GMA-12 DFCs

Summary of Environmental Stewardship's Comments and Requests

**Presented to
GMA-12
December 10, 2020, Virtual Meeting**

Figure 1. Predicted reduction of discharge of groundwater into the mainstream Colorado River due to combined pumping (Old GAM).

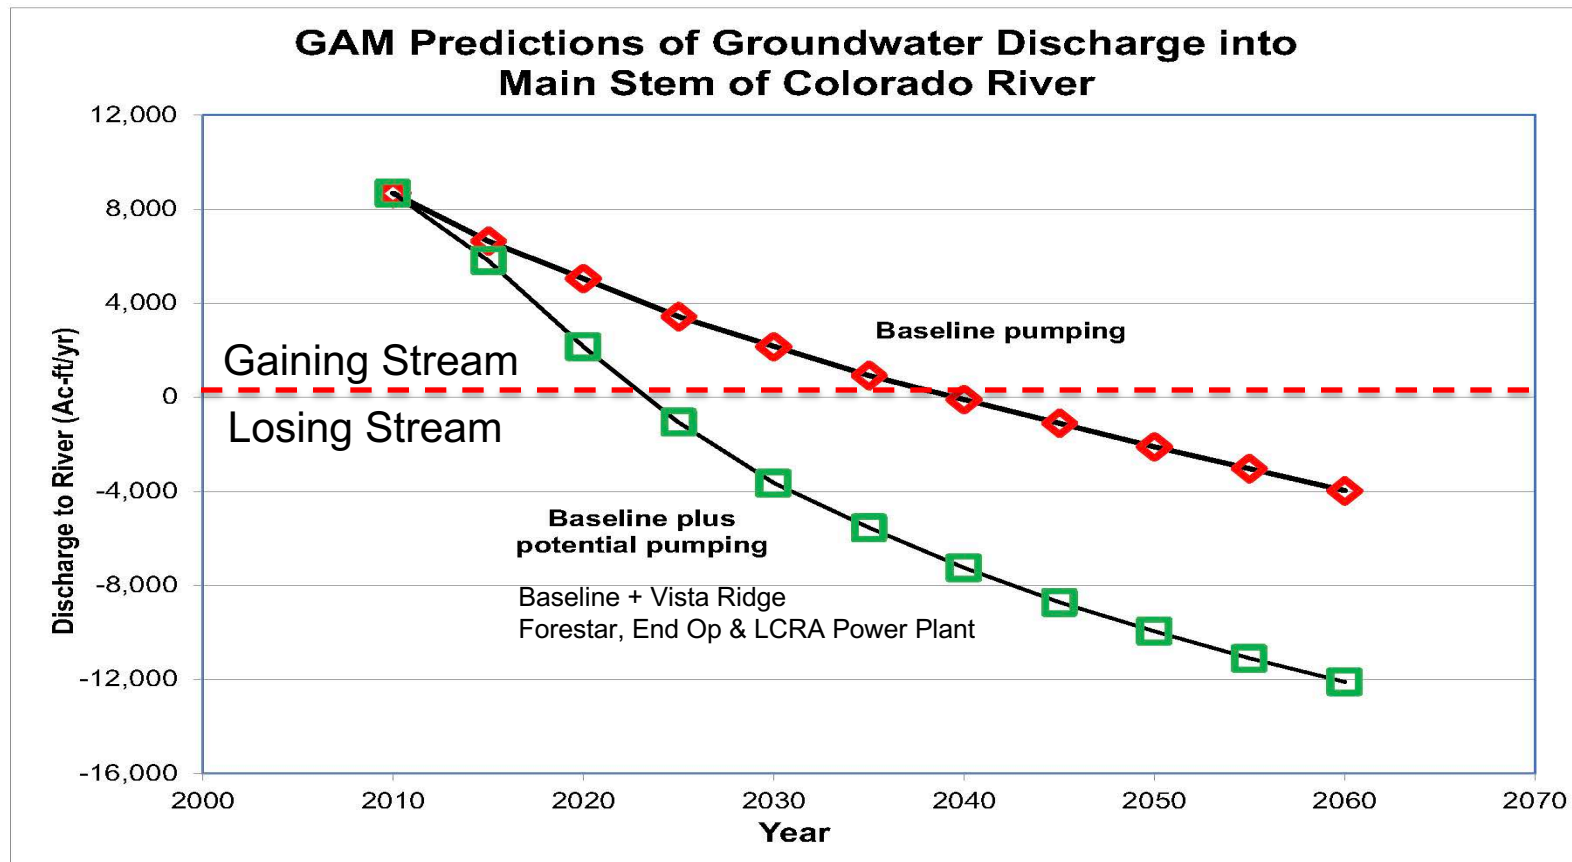
- Adopted 2017 DFCs (Old GAM):

Figure 2. Predicted reduction of discharge of groundwater into the mainstream Colorado River due to DFC Run 3 and Scenario S-7 (New GAM).

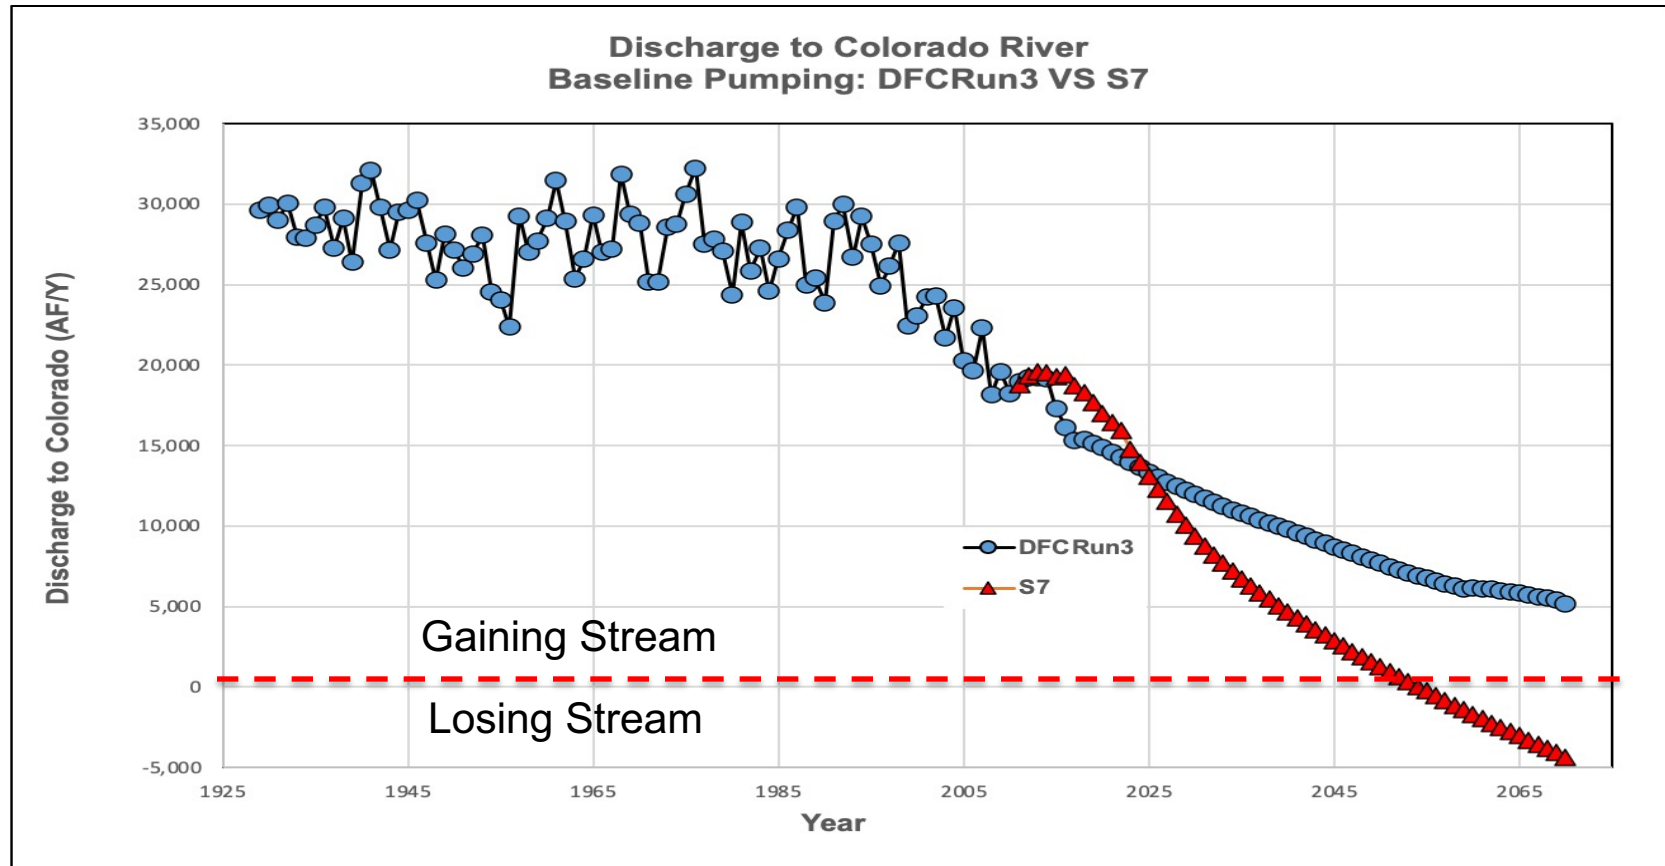
- Average Pumping Amount:
 - DFCRun3 = 50,900 acre-feet per year average pumping all aquifers
 - Scenario S-7 = 116,000 acre-feet per year average pumping all aquifers
- The New 2018 GAM (DFCRun3- Current Adopted DFCs) predicts:
 - Pumping *will reduce discharge* to the main stem of the Colorado River by about 14,000 ac-ft per year from 2010 to 2070.
 - Pumping *will not reverse its historical relationship* to the aquifers in the current planning period.
- The New 2018 GAM (S-7)predicts that:
 - Pumping *will reduce discharge* to the main stem of the Colorado River by about 24,000 ac-ft per year from 2010 to 2070.
 - Pumping *will reverse its historical relationship* to the aquifers by about 2050.

- **By comparison:**
 - **The new GAM predicts that Scenario S-7 will reduce outflows by about 10,000 ac-ft per year more than DFC Run 3.**
 - **The new GAM predicts that Scenario S-7 will cause a reversal in the surface water-groundwater relationship to occur about 2050 whereas DFC Run 3 does not predict a reversal within the planning period.**
 - **Scenario S-7 (New GAM) is comparable to Baseline + potential pumping in the Old GAM.**
 - **Both predict the same magnitude of reduced outflow from the aquifer to the Colorado River; about 22,000 to 24,000 acre-feet per year.**

Figure 3: Groundwater Discharge to four tributaries of the Colorado River located primarily in Bastrop County, TX (New GAM).

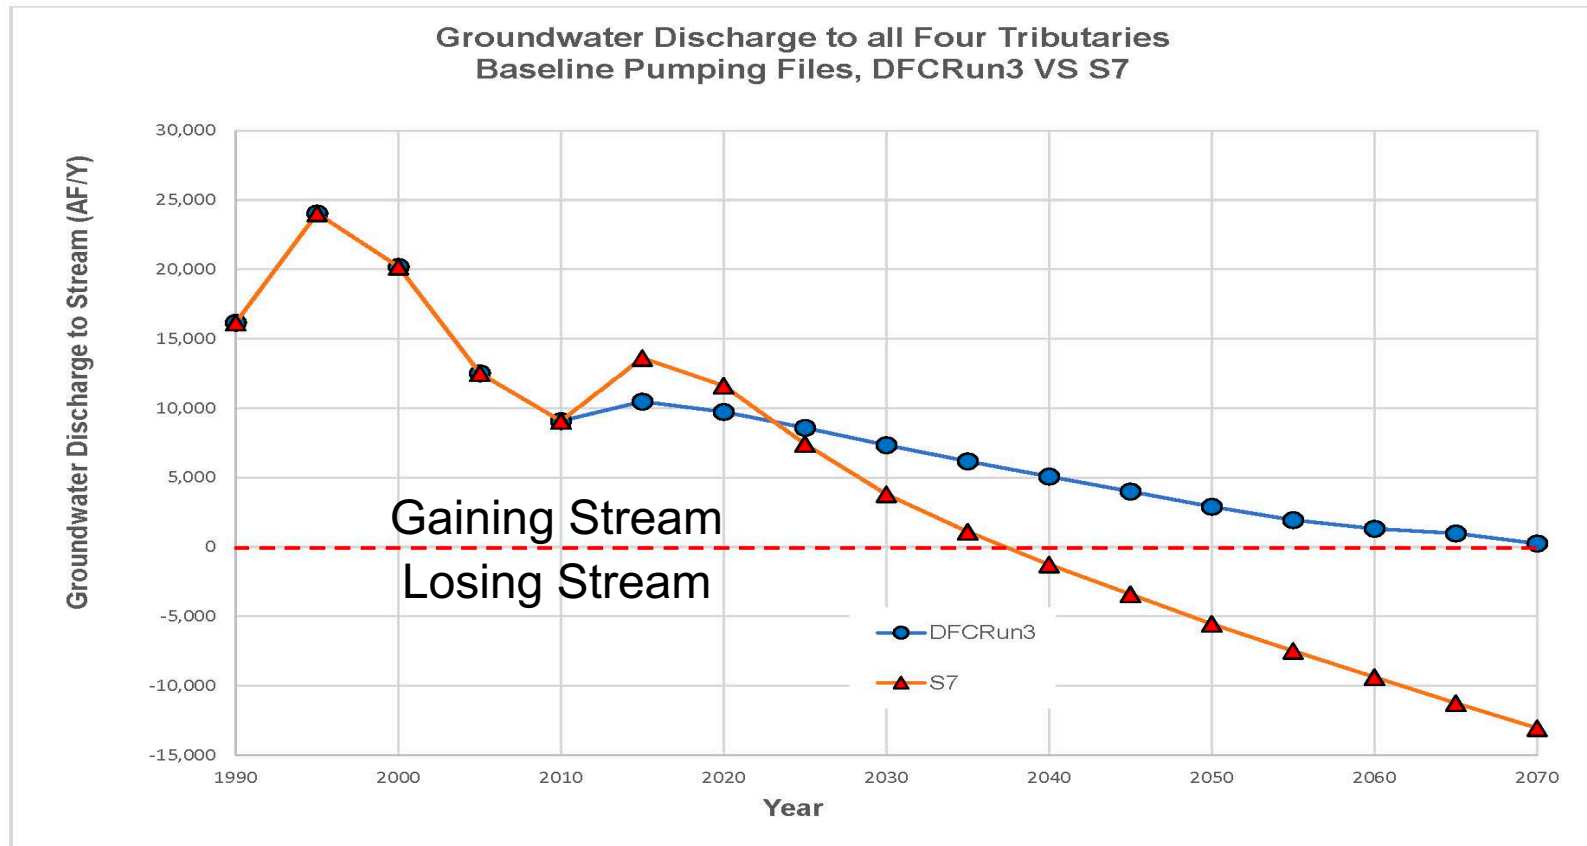
- **Combined discharge to the four tributaries:**
 - **Historic outflows were significantly higher than during development**
 - **Outflows declined during the early development period**
 - **Outflows are predicted to continue to decline as pumping increases in the current development period**
 - **Gain/Loss relationship will reverse during the planning period for currently adopted DFCs**
 - **S-7 pumping will accelerate the reversal by about three decades**

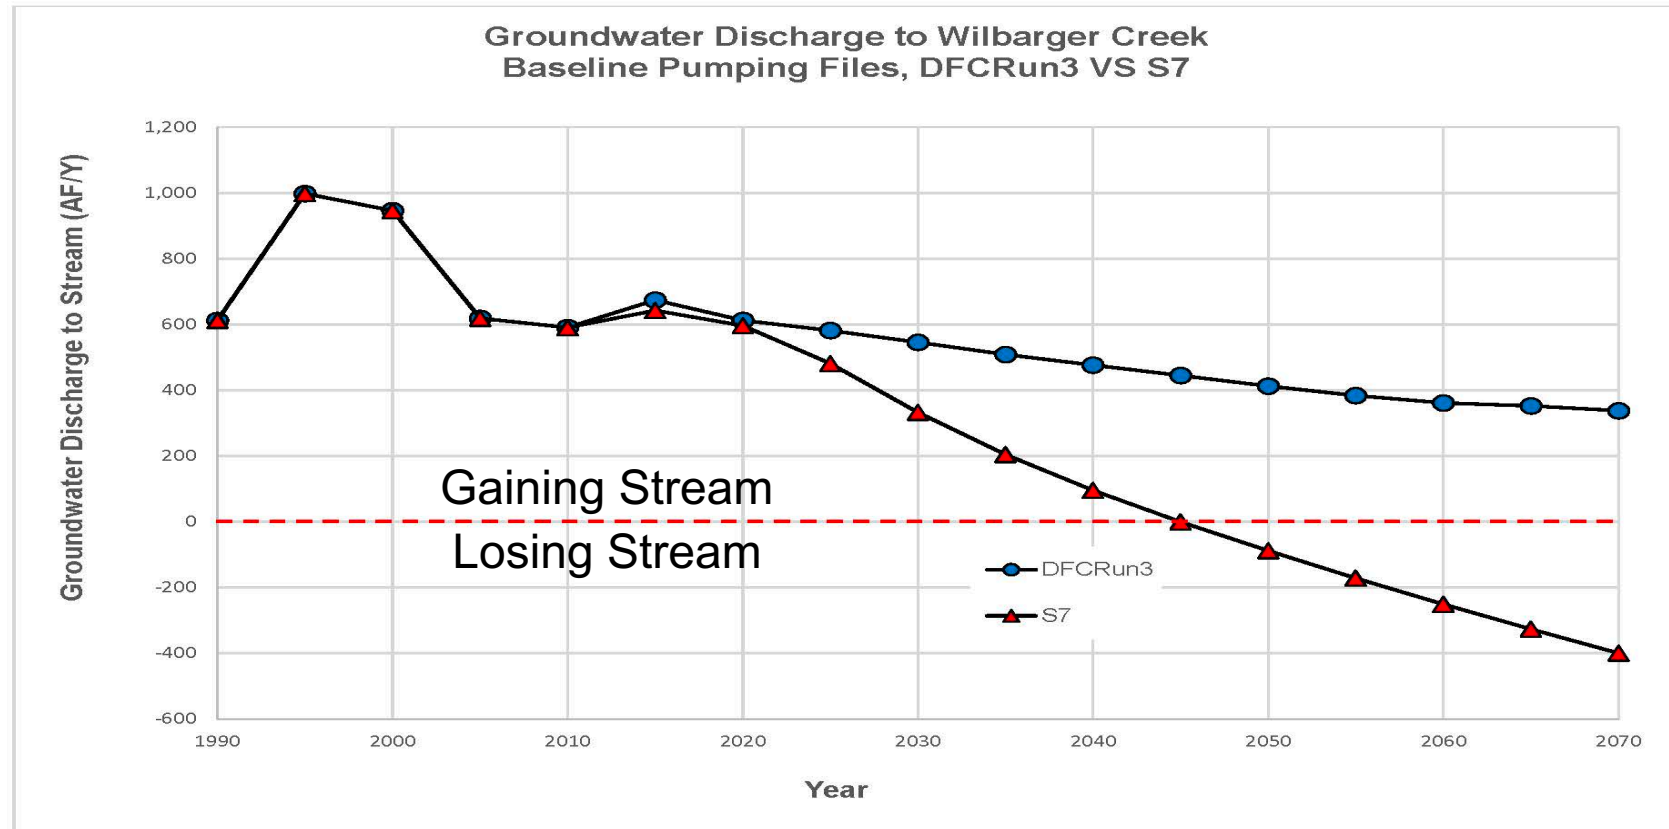
Figure 4. Wilbarger Creek: Overall, S-7 pumping caused a greater decline in outflows from the aquifers than DFC Run 3. Likewise, S-7 pumping is predicted to cause a reversal in the surface water-groundwater relationship whereas DFC Run 3 does not predict a reversal. Wilbarger Creek flows across the outcrops of the Hooper, and the Simsboro.

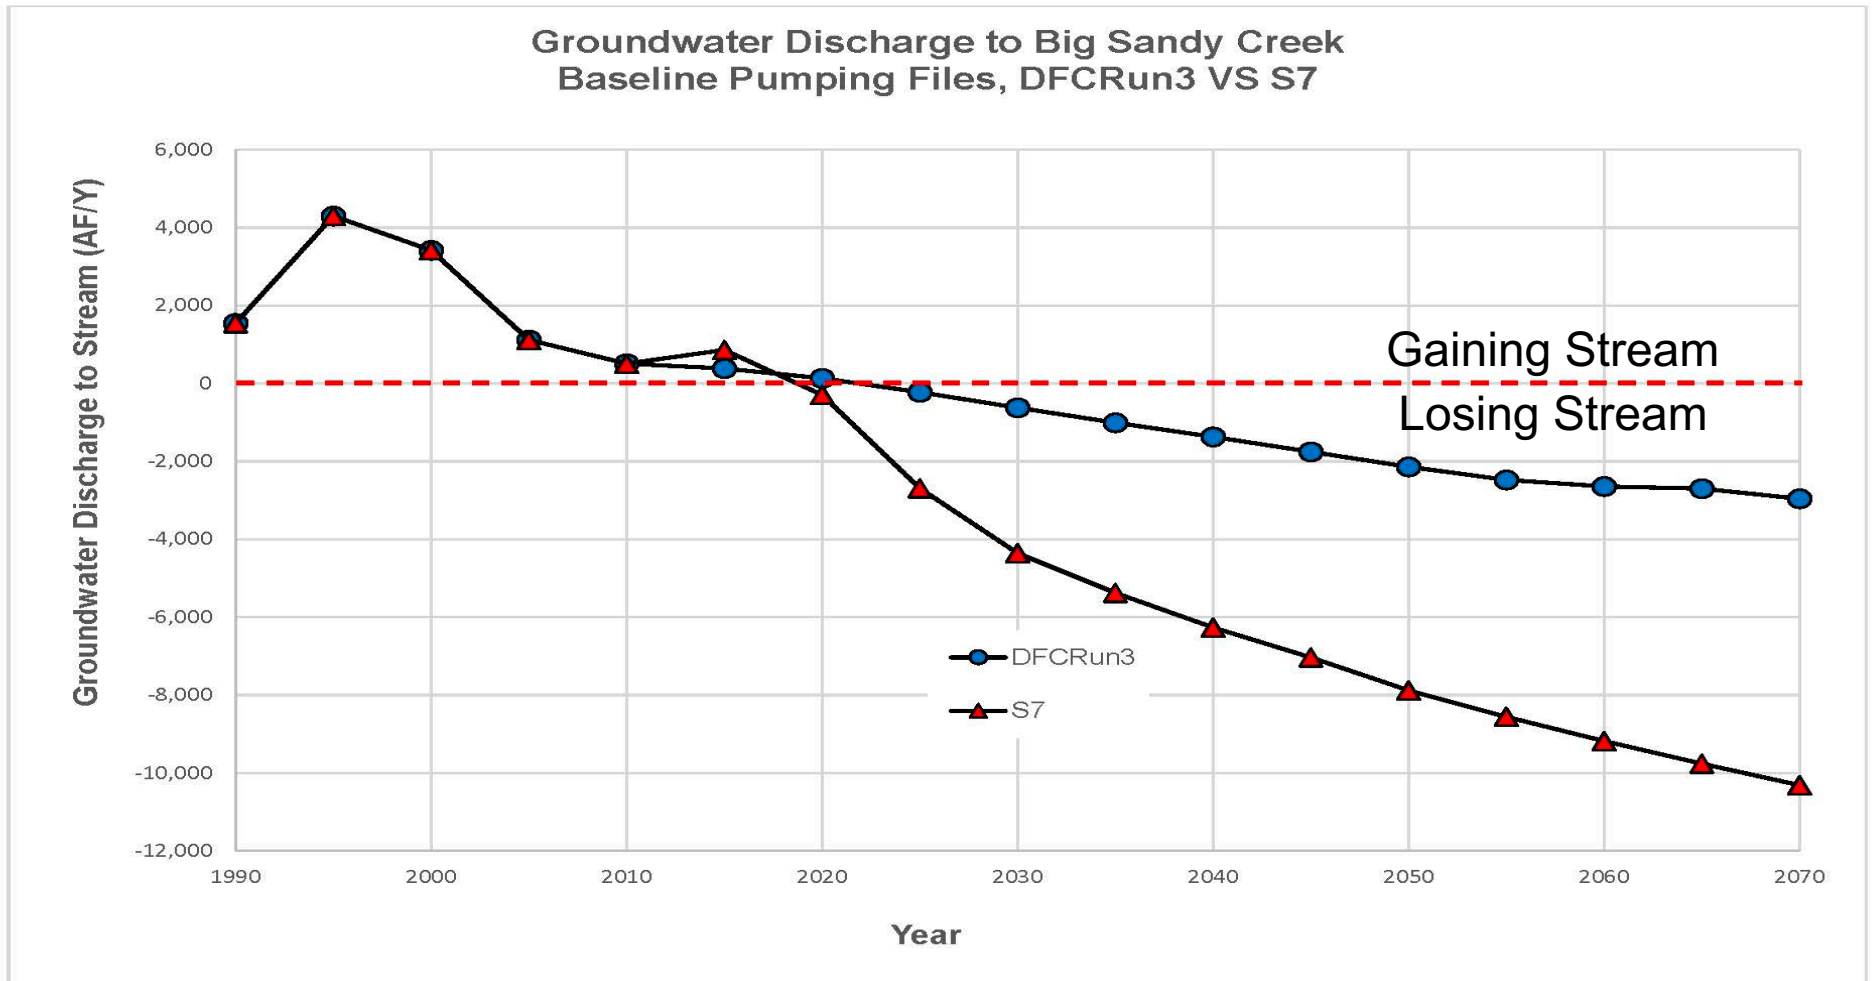
Figure 4. Big Sandy Creek: Overall, S-7 pumping caused a greater decline in outflows from the aquifers than DFC Run 3. Both DFC Run 3 and S-7 pumping predict a reversal in the surface water-groundwater relationship has already occurred. Big Sandy Creek flows across the outcrops of the Hooper, Simsboro, and Calvert Bluff.

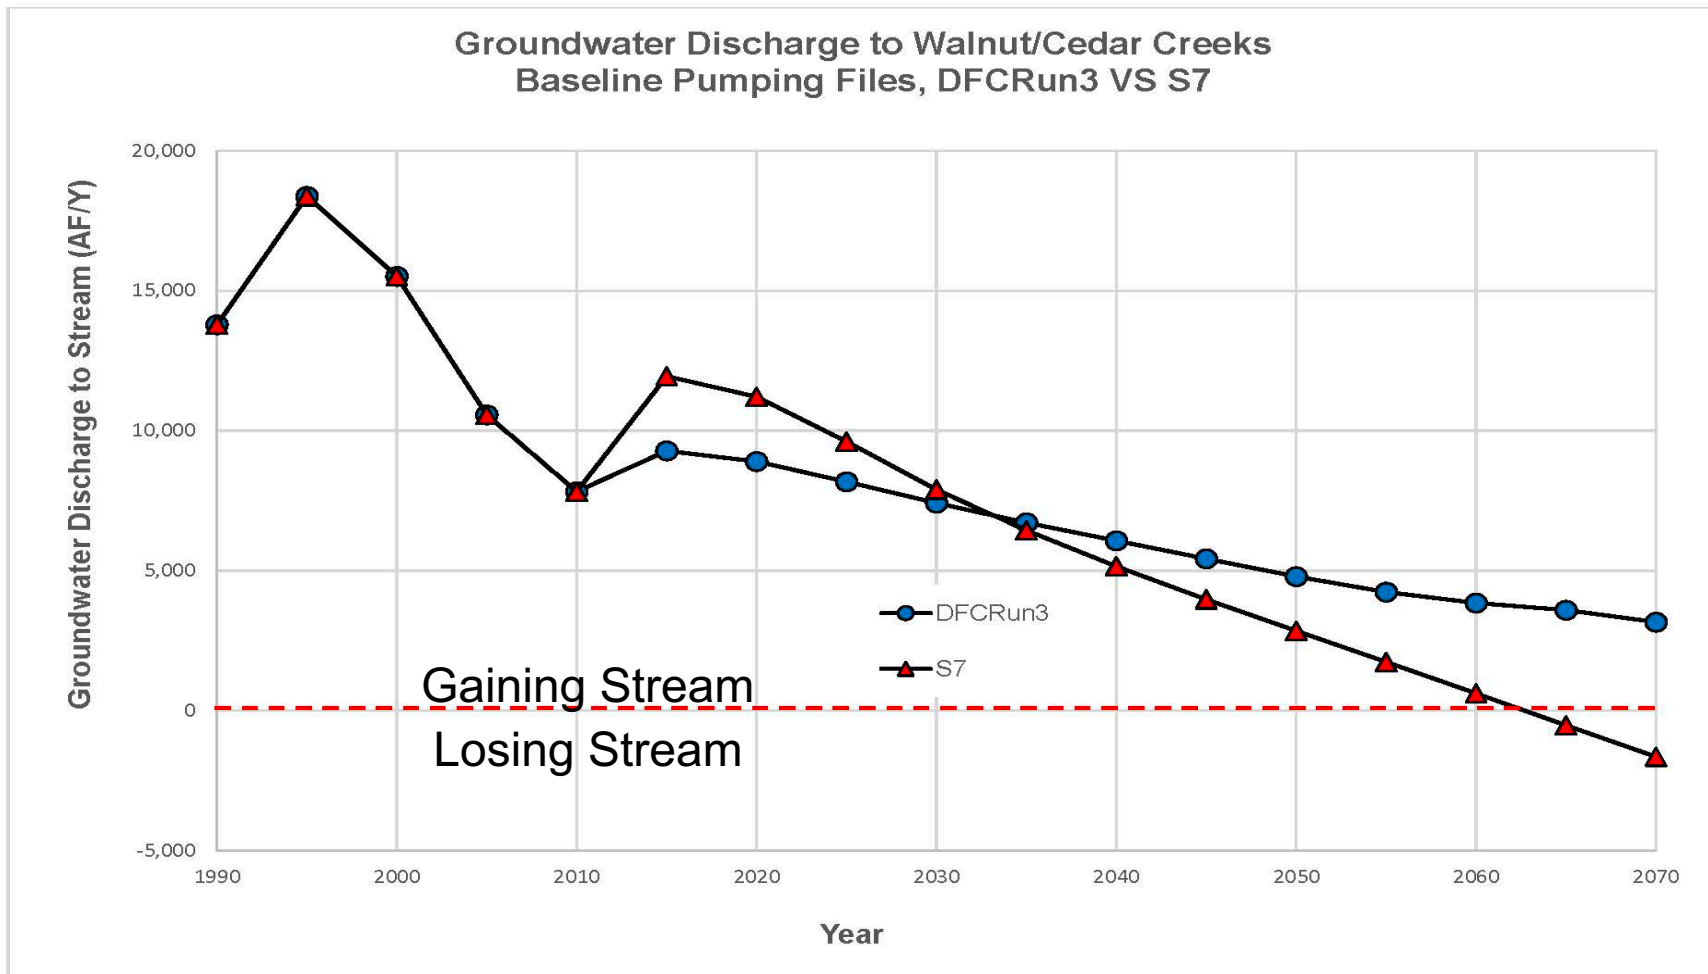
Figure 4. Walnut/Cedar Creek: Overall, S-7 pumping caused a greater decline in outflows from the aquifers. Likewise, S-7 pumping is predicted to cause a reversal in the surface water-groundwater relationship whereas DFC Run 3 does not predict a reversal. Walnut/Cedar flows across the outcrops of the Hooper, Simsboro, Calvert Bluff, and Carrizo.

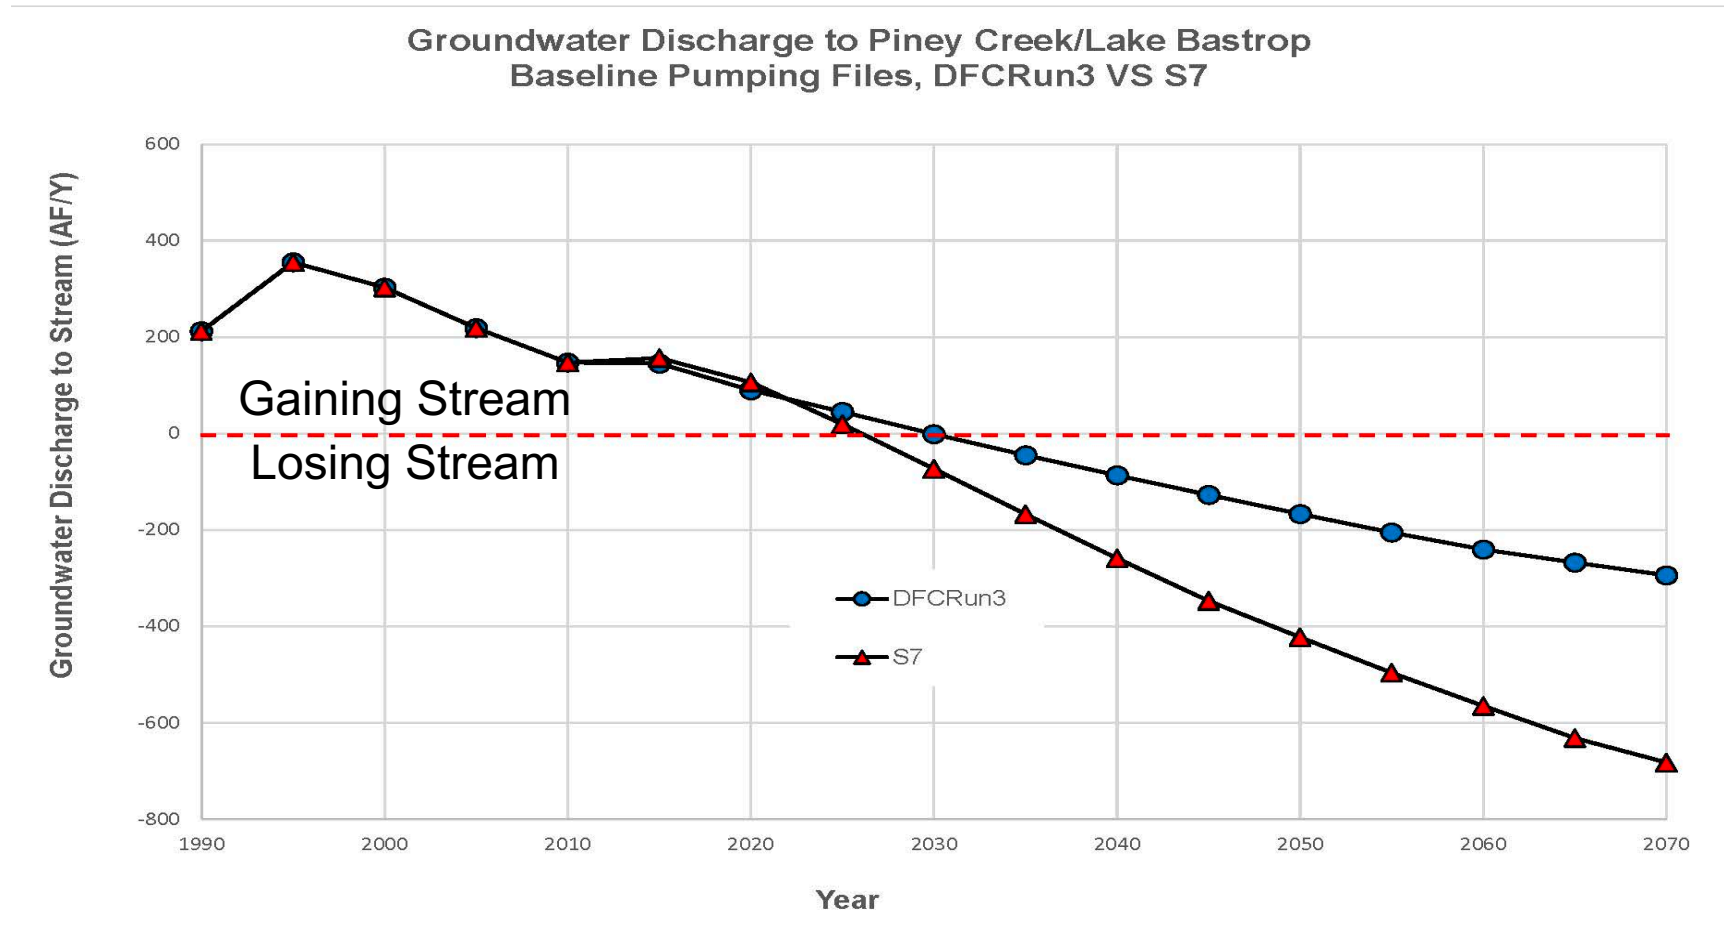
Figure 4. Piney Creek/Lake Bastrop: Overall, S-7 pumping caused a greater decline in outflows from the aquifers. Both S-7 pumping and DFC Run 3 are predicted to cause a reversal in the surface water-groundwater relationship. Piney Creek/Lake Bastrop flows across the outcrops of the Calvert Bluff and Carrizo.
